Access Compliance Report

Public Rights-of-Way

| Intersection ID: 44242 | Main Street: KIEV_DR | Cross Street: SUNSET_RD | Location: W |
| ADA ID: 8D54D9DF0EA5 | Ramp Type: Perp | Initial Pass/Fail: Fail | Overall Compliance: No |

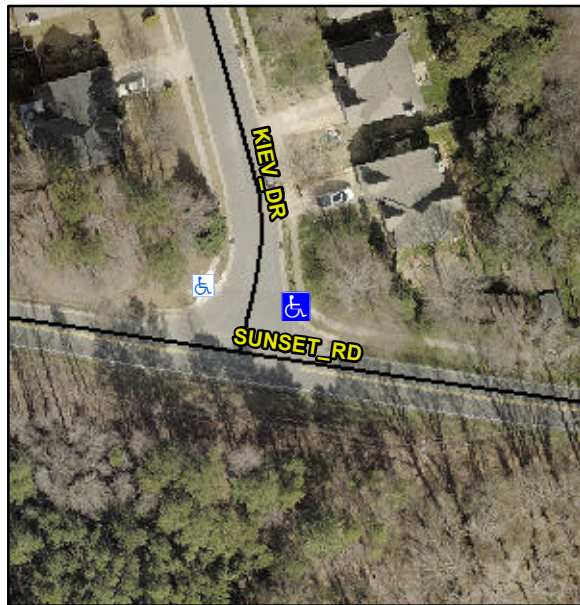
Not Found, R304.5.1, R304.2.2, R304.5.3

| Compliance | Description | Data | Compliance | Description | Data |
|------------|-----------------------|-------|------------|-----------------------------|------|
| N/A | Ramp Length (in) | 48.0 | No | Ramp Slope (%) | 9.3 |
| No | Ramp Width (in) | 46.0 | No | Ramp XSlope (%) | 2.2 |

Remove & Replace Entire Ramp.
